Project #21-052
Logan C-Store Heiner Land Co.
Located at 1977 S 1000 W

<i>Project Name:</i>	Logan C-Store Heiner Land Co.
<i>Proponent / Owner:</i>	Heiner Land Co., John Heiner / 10 th & 89 LLC, Lal Jaswinder
<i>Project Address:</i>	1977 S 1000 W
<i>Request:</i>	Design Review Permit
<i>Current Zoning:</i>	Commercial (COM)
<i>Type of Action:</i>	Quasi-Judicial
<i>Hearing Date</i>	September 9, 2021
<i>Submitted By:</i>	Tanya Rice, Planner II

Staff recommends that the Planning Commission **conditionally approve** a Design Review Permit for Project #21-052, Logan C-Store Heiner Land Co., for a convenience store and sixteen fuel dispensing units located at 1977 S 1000 W, TIN #03-207-0003 and #03-006-0043.

A.2

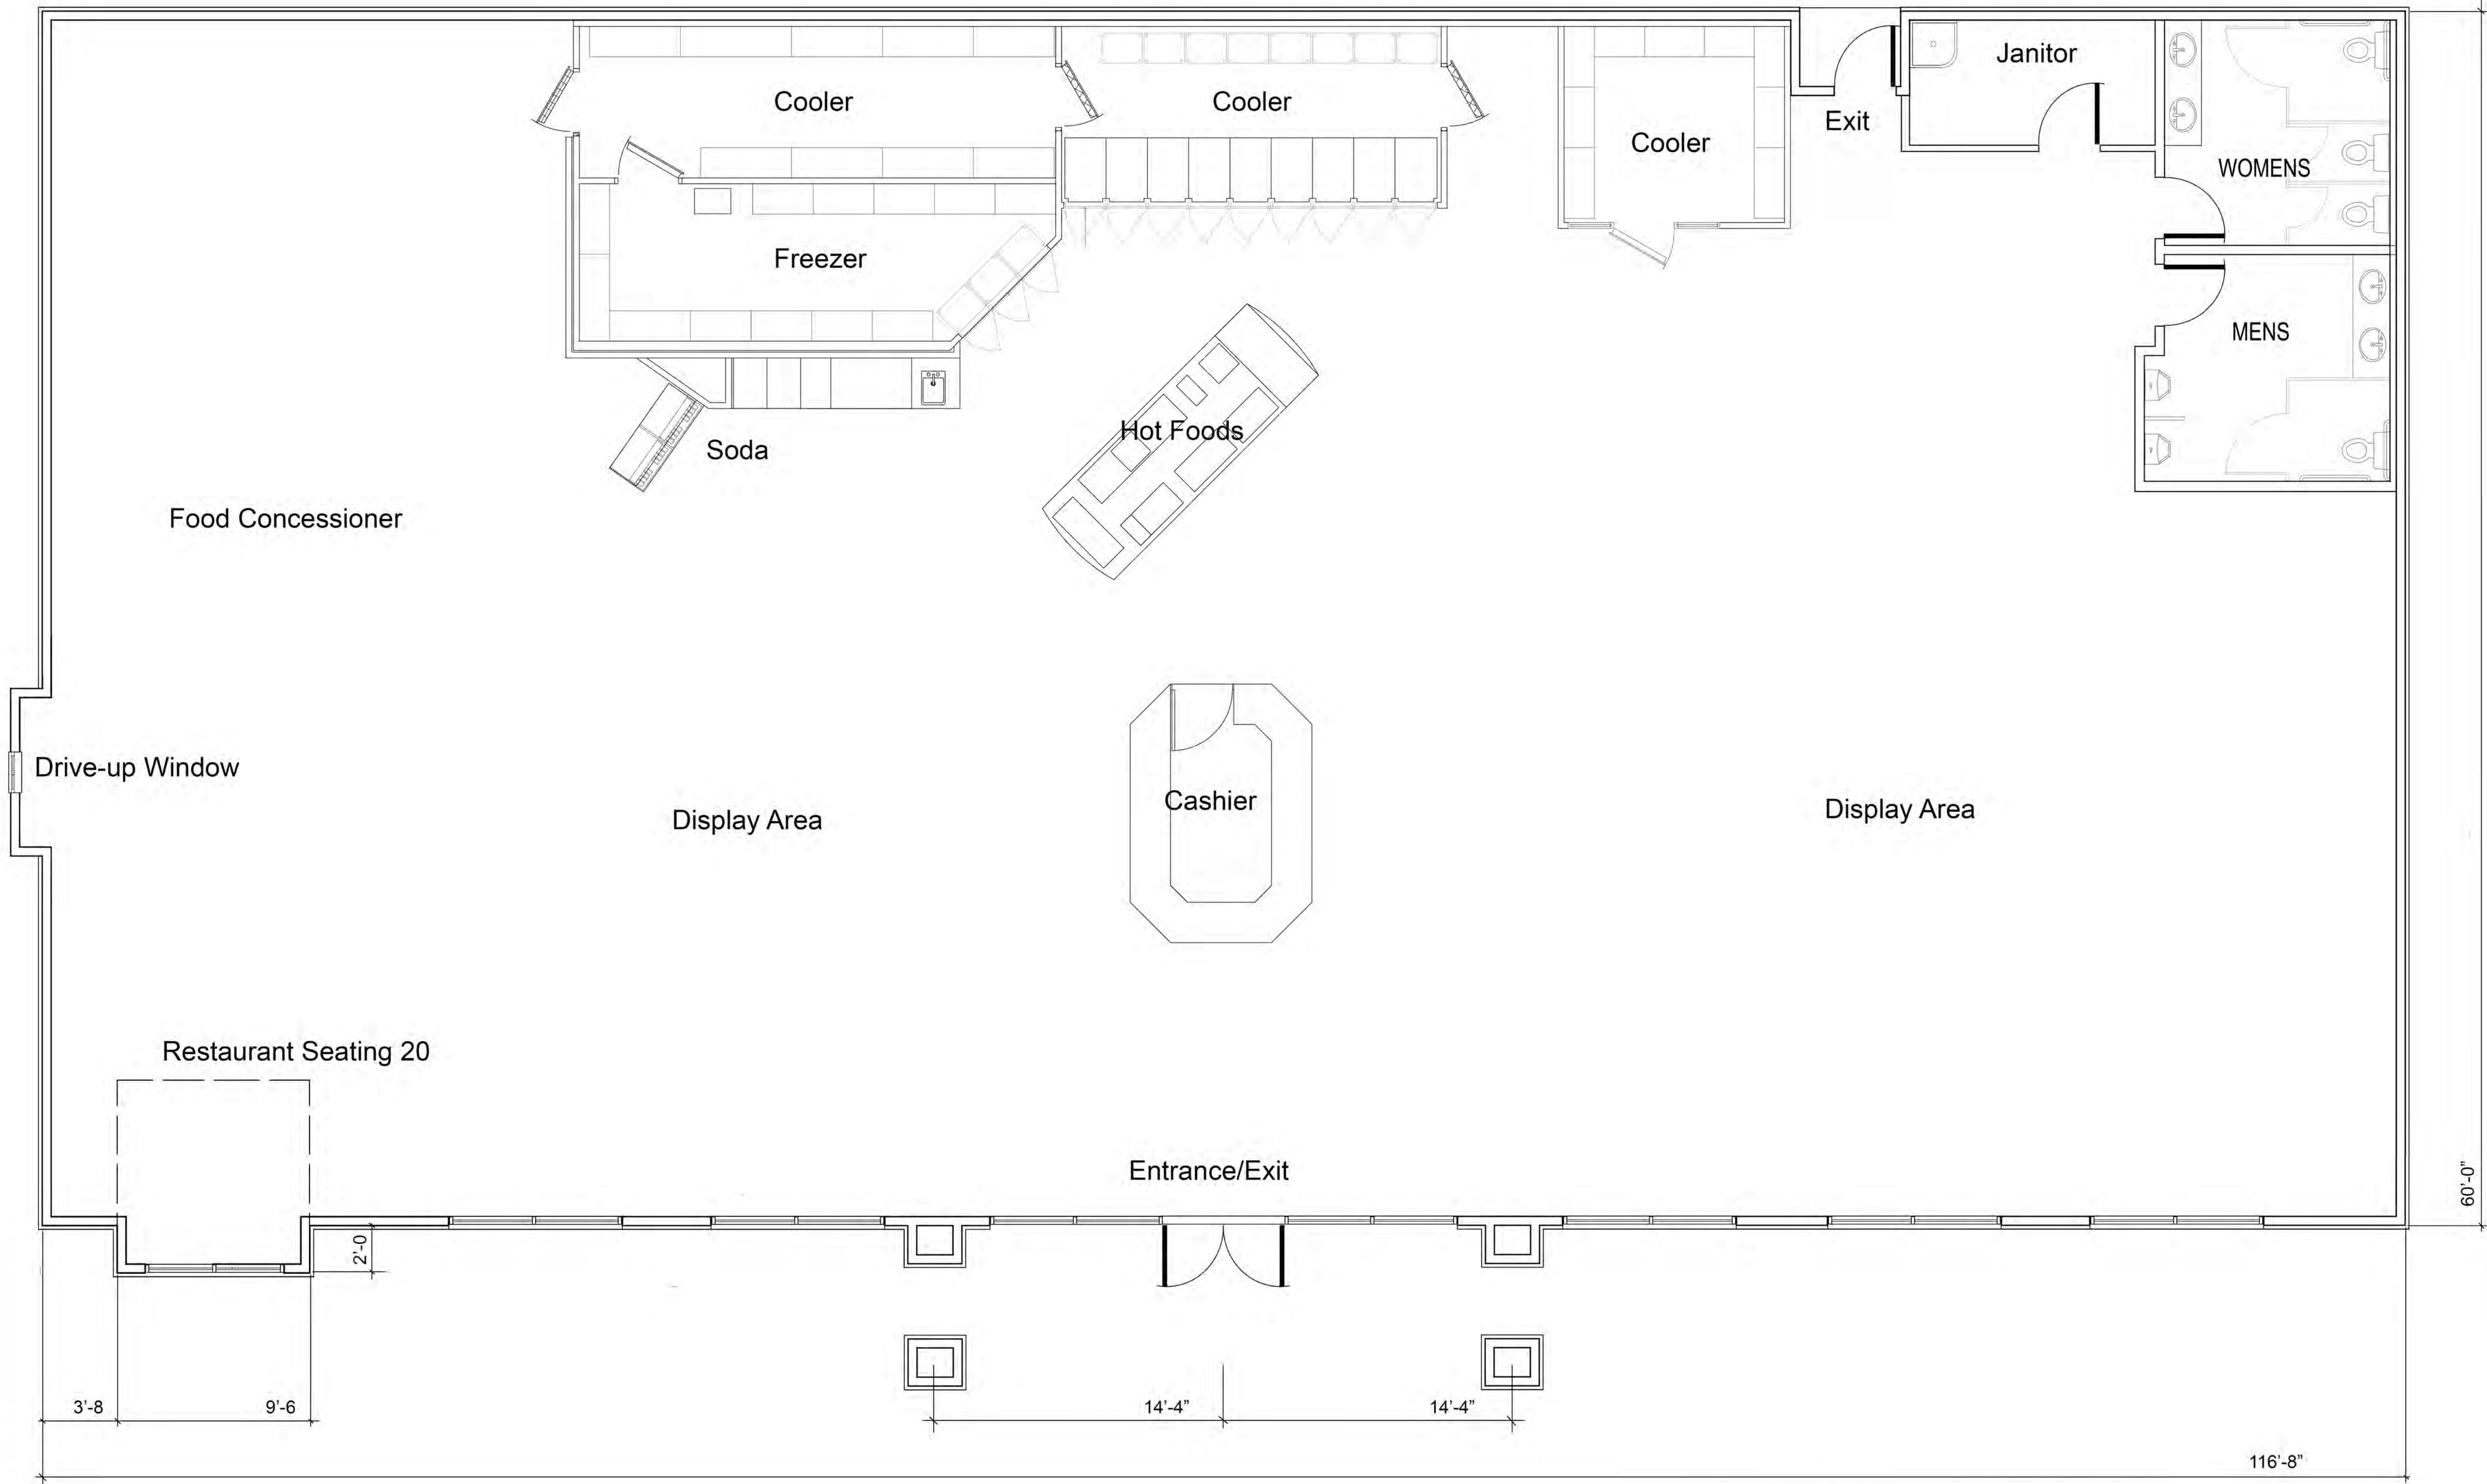
The LDC requires 30% fenestration on the ground floor frontage and all exposed sides. The fenestration on the front façade of the store is approximately 31% while all other elevations lack the minimum 30% fenestration. Condition #4 requires the addition of fenestration on all four sides to meet minimum LDC fenestration requirements.

The LDC requires four-sided architectural design. All sides of the building are required to receive equal design consideration including windows, doors and architectural treatments. In general, no building can have blank flat walls. The applicant shall carry similar materials, finishes and fenestration around the entire building as required in condition #5.

3. Bike parking shall be provided to accommodate a minimum of 4 bikes.
4. The rear and both side façades shall comply with 30% fenestration requirement.

5. Four-sided architecture is required. Materials, finishes and fenestration shall be consistently applied on all four sides of the building.
6. A performance landscaping plan, prepared in accordance with §17.32 of the LDC, shall be submitted for approval to the Community Development Department prior to the issuance of the building permit. The plan shall include the following:
